TOWN OF UNDERHILL

Development Review Board

BETSY EVANS
SKETCH PLAN REVIEW
Docket #: DRB-20-03

Project Proposal:	Sketch Plan Review of Betsy Evans, on Behalf of Edgmont House, LLC, for a proposed 2-Lot Subdivision of property located at the aforementioned address (see Exhibit F).
--------------------------	-------------------------------------------------------------------------------------------------------------------------------------------------------------------------

TABLE 2.7 – SOIL & WATER CONSERVATION

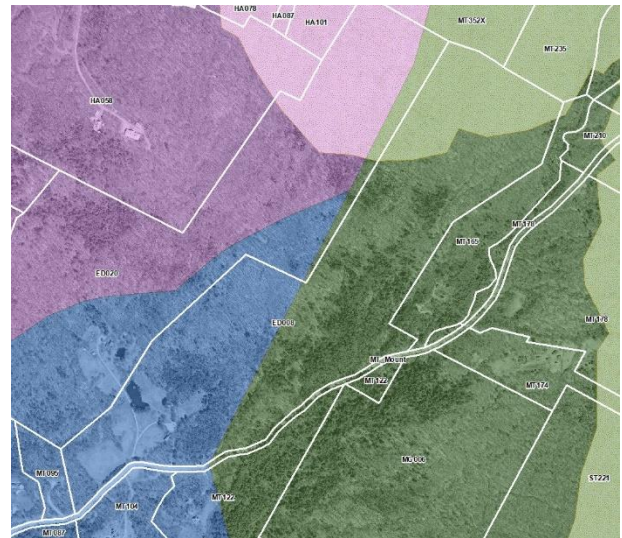
- The proposed lot appears to be configured in a way that will be located in both the Water Conservation and Soil & Water Conservation zoning districts.
- Should the construction of a single-family dwelling occur in the Soil & Water Conservation District of this lot the impact would be low, and consistent with nearby development.
- Upon the submission of engineering plans, Staff will have a better understanding of how the proposed development conforms with the purpose statement of this district.
- The northern area of the lot contains area above 1500 ft. in elevation (see directly to the right), where all new development is prohibited. New development is NOT anticipated to be proposed or located in this area.

SECTION 3.17 – SOURCE PROTECTION AREAS

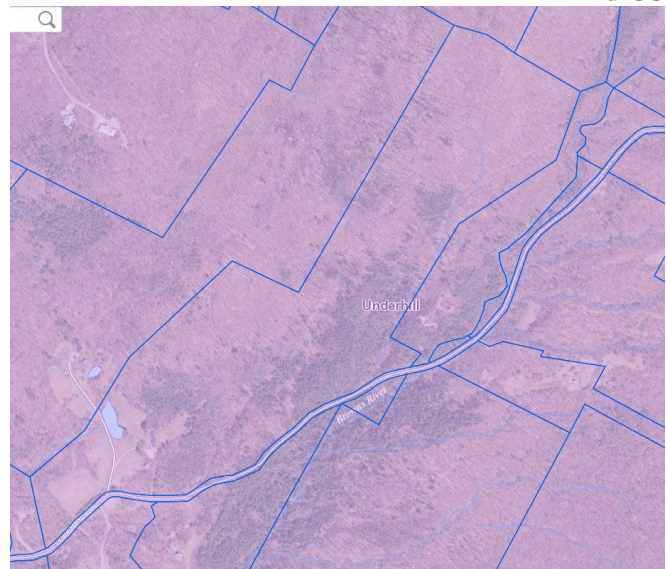
- The subject lot is located entirely within the Groundwater Source Protection Area.
- Avoiding the siting of an assumed single-family dwelling outside of this Source Protection Area is not feasible; however, single-family dwellings are exempt from requiring additional review under this Section per § 3.17.B.

SECTION 3.18 – STEEP SLOPES

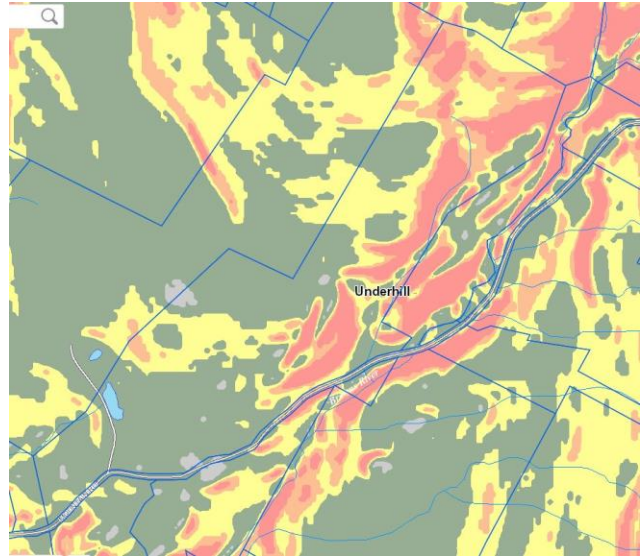
- Areas of steep slopes (15-25%) and very steep slopes (>25%) are present on the existing lot (see directly to the right).
- The proposed lot will contain areas of steep slopes and very steep slopes.
- Upon the submission of engineering plans, Staff will have a better understanding of how the proposed development driveway conforms with the requirements of this Section.

SECTION 3.19 – SURFACE WATERS & WETLANDS

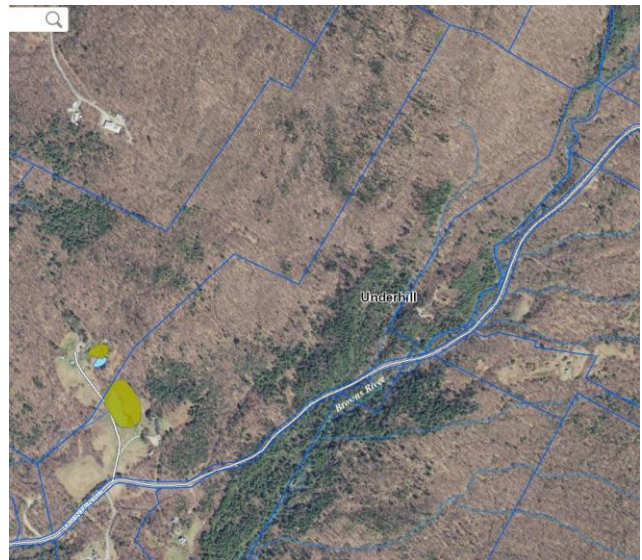
- An unnamed stream is located on the parent lot, which feeds the Brown's River.
- The unnamed stream does not appear to bisect the proposed new lot, and therefore, no development is likely to be proposed within the stream's vicinity.
- A pond and unnamed stream are located within the vicinity of the existing single-family dwelling, which will stay with the parent lot.
 - Staff is unaware of any new development in this area.
- An area of wetlands is located in the area where the pond is located, and not in the vicinity of the proposed new lot; therefore, any new development associated with the proposed new lot is not anticipated to impact any wetlands or associated buffers.
